Access Compliance Report Public Rights-of-Way (Curb Ramps)

Main Street: VANDERLIP_AVE		Cross Street: VANDERLIP_AVE		Location:	S
ADA ID: RPAT211006091657	Ramp Type:Type 1 - Perpendicular	Initial Pass/Fail: Fail	Overall Compliance: No	Severity Score:	15

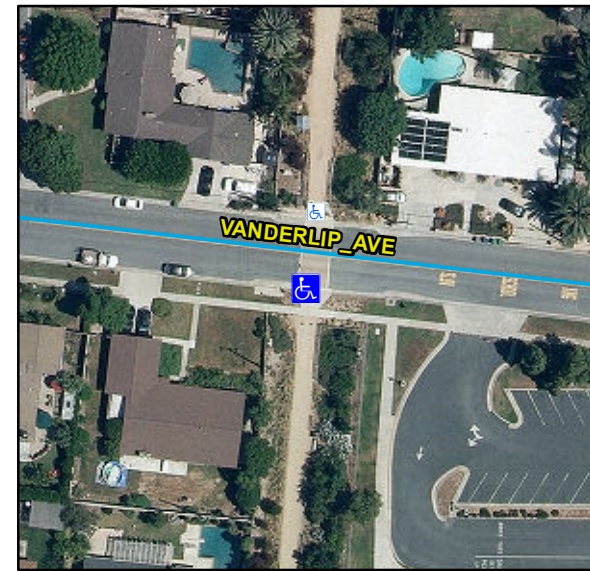
Compliance	Description	Data	Compliance	Description	Data
N/A	Ramp Length (in)	101	N/A	Flare Type LT	
Yes	Ramp Width (in)	112			N/A
No	Ramp Run Slope (%)	12	N/A	Flare Slope LT (%)	N/A
Yes	Ramp Cross Slope (%)	1.4	N/A	Flare Traversable LT	N/A
N/A	Landing Present	N/A	N/A	Flare Type RT	
N/A	Landing Length (in)	N/A			N/A
N/A	Landing Width (in)	N/A	N/A	Flare Slope RT (%)	N/A
N/A	Landing Run Slope (%)	N/A	N/A	Flare Traversable RT	N/A
N/A	Landing Cross Slope (%)	N/A	N/A	DWS Provided	N/A
N/A	Landing Movement Obstructed?	N/A	N/A	DWS Contrast	N/A
	Landing Movement Type	N/A	N/A	DWS Length (in)	N/A
N/A	Landing Shared	N/A	N/A	DWS Full Width	N/A
N/A	Clear Space	N/A	N/A	DWS Offset Left (in)	N/A
N/A	Clear Space To Crosswalk (in)	N/A	N/A	DWS Offset Right (in)	N/A
N/A	Marked Crosswalk 1	Yes	N/A	Marked Crosswalk 2	N/A
	Crossing 1 Direction	N		Crossing 2 Direction	N/A
	Marked Crosswalk 1 Width (in)	120		Marked Crosswalk 2 Width (in)	N/A

Remove & Replace Entire Ramp.

R304.2.2, STD 1115
